Karsner - Kennedy Hse
 Florence
 1828

Re: Karsner House, Project No. 87060

SKETCH SECTION
KORSNER HOUSE

c.1828 Karsner-Kennedy Hse, 303 N. Pine St., Florence AL.
 photos Nov. 1994 H.P. Jans FAIA for minor restor. repairs
 (original restor. by Doug Fuller, Arch. Designer, in c.1976, with
 much speculation on dormer & porch:

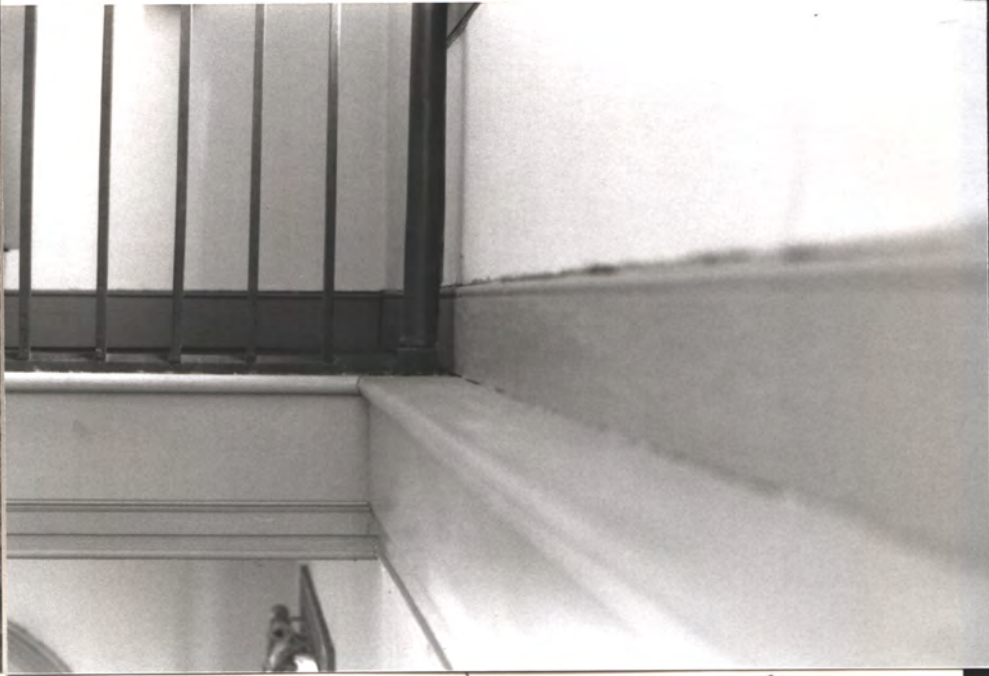
±3"±4" belly in S. wall ±4" above FL.

1 1/2" ± GAP DUE TO WALL
MOVING (BELLING) SOUTH
STAIR BASE

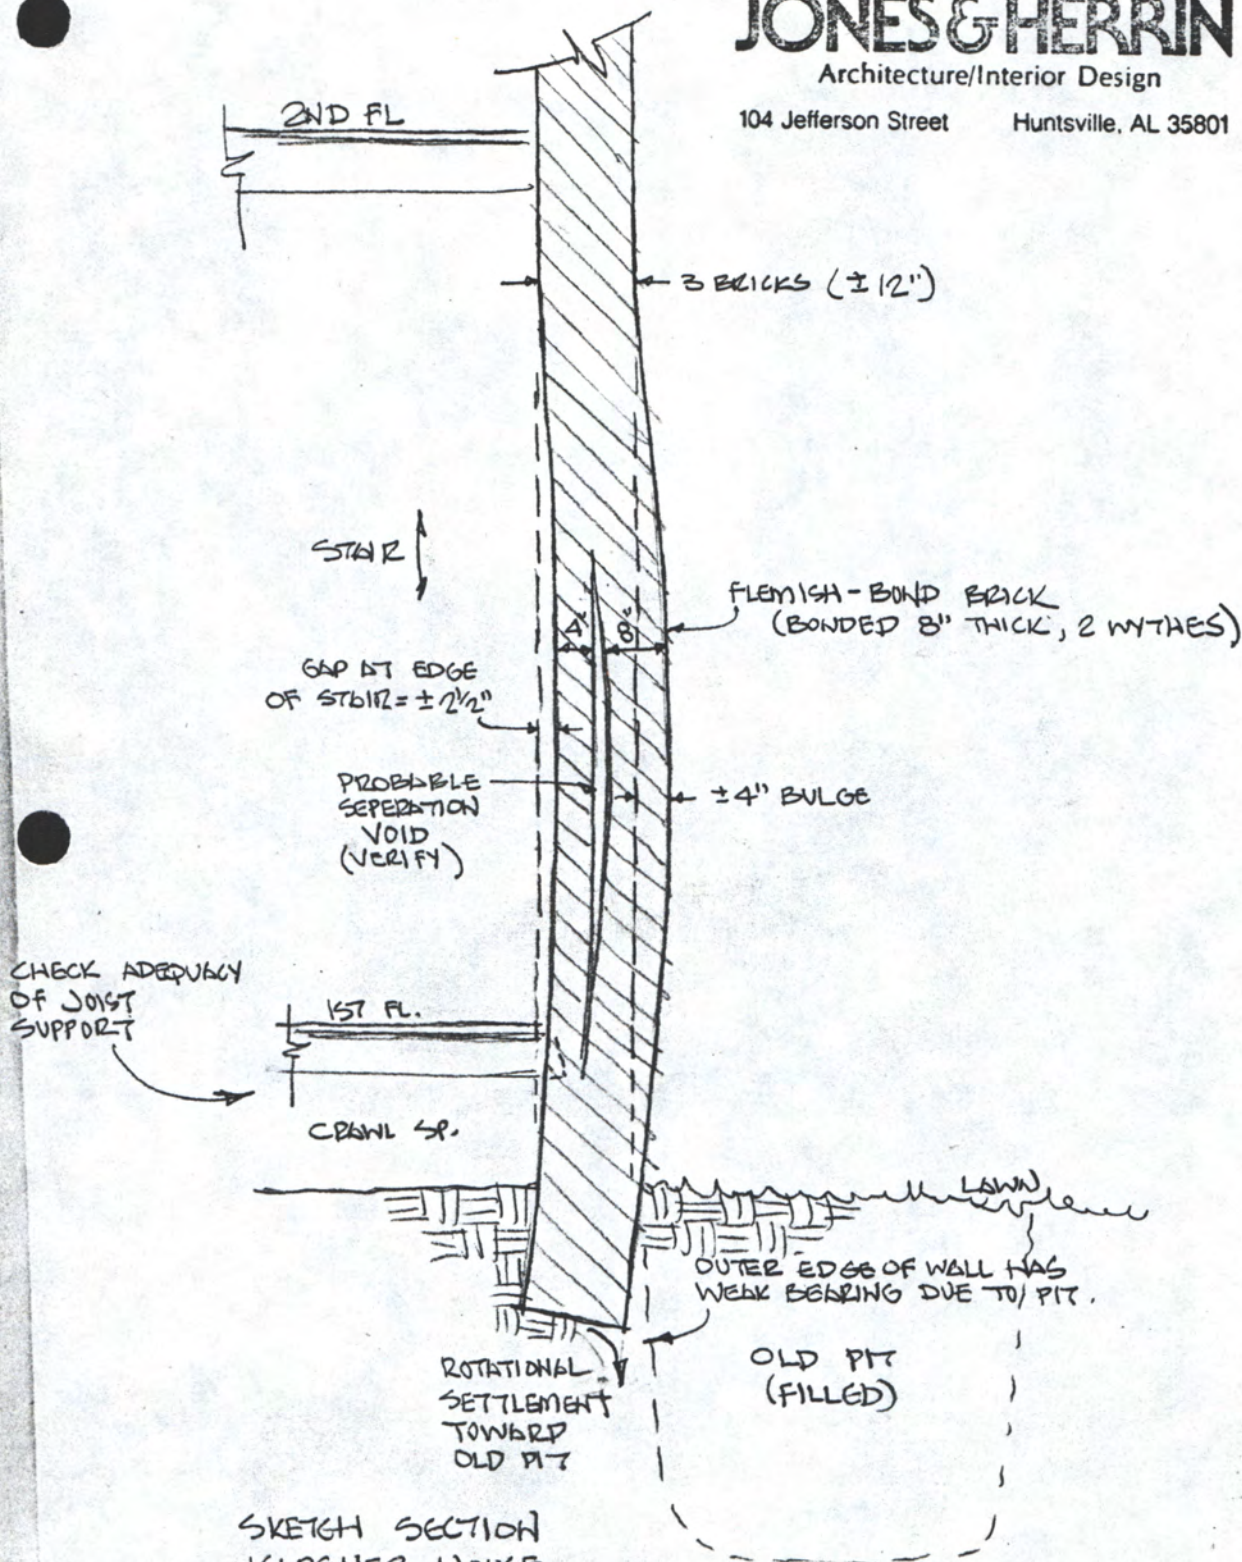
Attached is a sketch of what appears to be happening to the Karsner House south wall, based on the evidence so far. Further investigation may add to or change this supposition.

3. Determine if the outer 8 inches (which is bonded together by the Flemish-bond headers) has separated from the inner 4 inches. The amount of horizontal deformation indicates that this has probably happened (4 inches deformation on the outside, 2.5 inches on the inside), leaving a void inside the wall of up to 1.5 inches wide and leaving only a 4 inch thick inside bearing wall. If this separation has occurred, the void must be filled with a grout which has these characteristics:

I feel the sensible thing is to not attempt to straighten the wall, since the bulge is not obvious to the ordinary observer. Where the inner wall has pulled away from the stair trim I would scribe a neat, flat 1x filler strip and insert it to fill the crack. Verify adequate bearing at the floor joists at both floors.

1. Test the soil to determine the extent and condition of soil that may need strengthening.
2. Stabilize the soil as needed, either by injecting cement under pressure, or by sectional insertion of a spread footing or reinforced concrete, whichever is cheaper and safer. If the latter method is used the wall would have to be well-braced during construction and might still involve more risk of collapse or settlement-cracking during the work. To be safe, the wall should also be braced during soil injection grouting and wall-void grouting.

- A. A grout that is more resilient than the old soft bricks, so that temperature expansion will not crack the bricks.
 - B. High adhesion, to re-bond the separated wythes of bricks.

Cements containing Portland cement cannot be used, for this material is hard and brittle, much harder than the old bricks, and would thus break up the old bricks in temperature movements.

S. Wall (settled & bulged out) PH

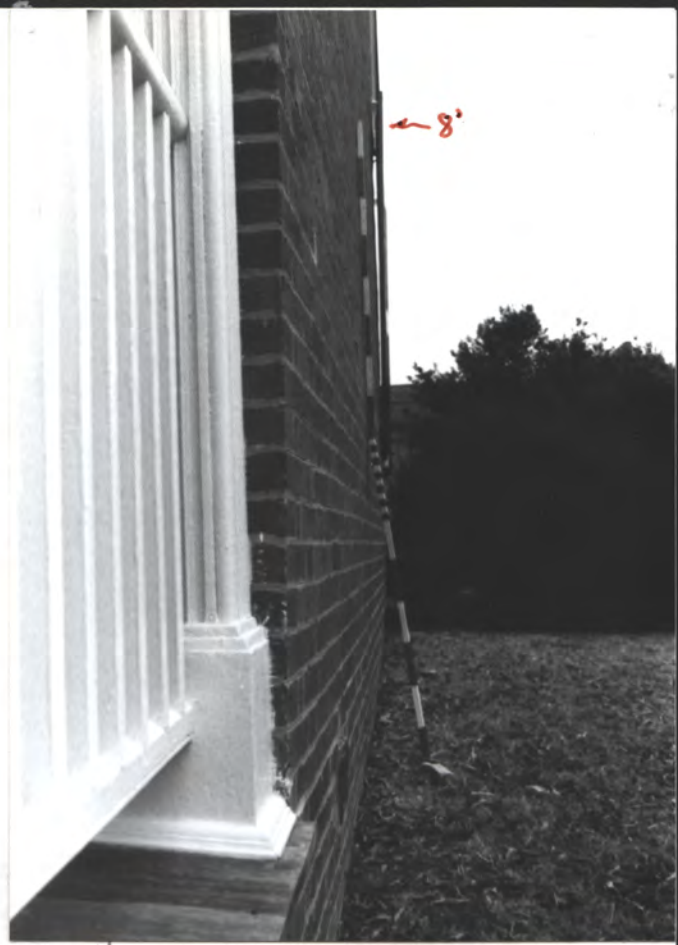
← entirely speculative in c.1976 PH

bulged out ± 2" at old trash pit by wall

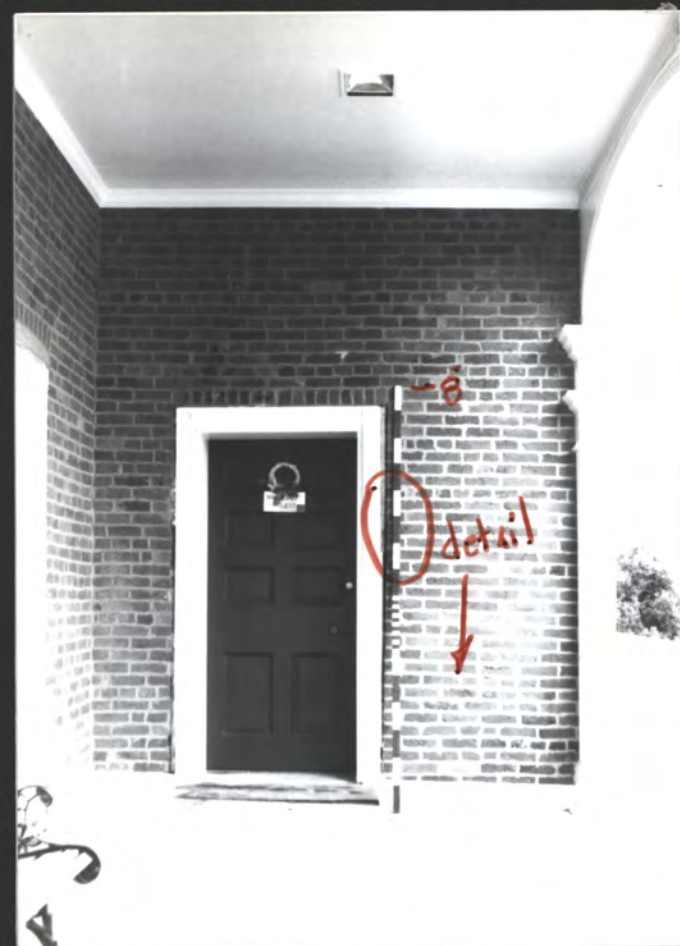
Note bulge ± 2"
at ± 4' ht.

close up of removed brick,
shows wall has not delaminated
at bulge

FL. 1 DW. RM. (w. y. porch)

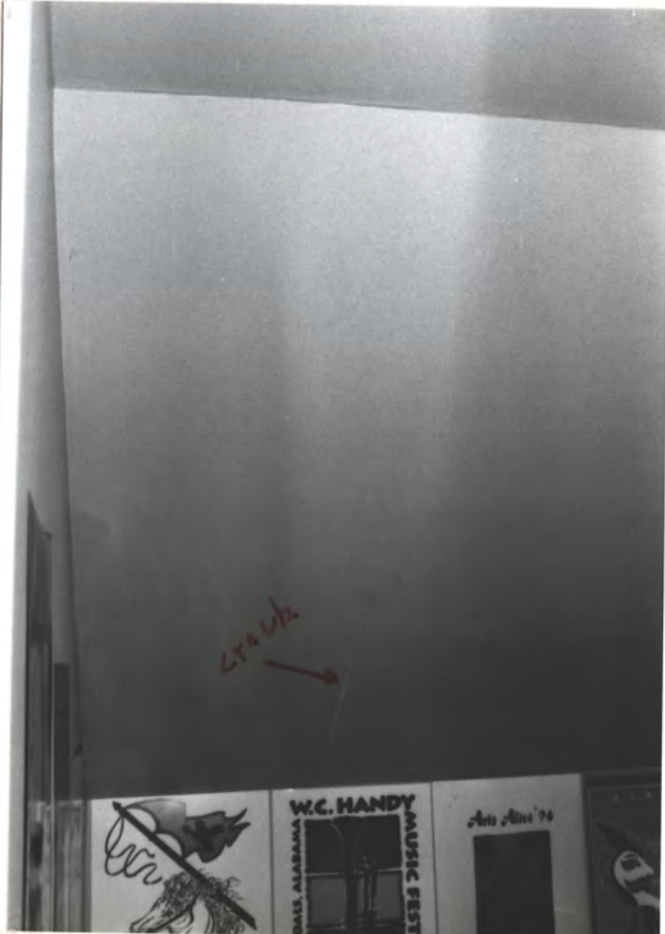
Fireplace surround should be plastered (top. 1800-1860)

Parlor hearth (sq. bricks should not have "mortar joints")

F.p. surround
should be
plastered.
Hearth =
incorrect
pattern &
should not
have wide
marker ribs
(should be
butted tight
w/ no marker)
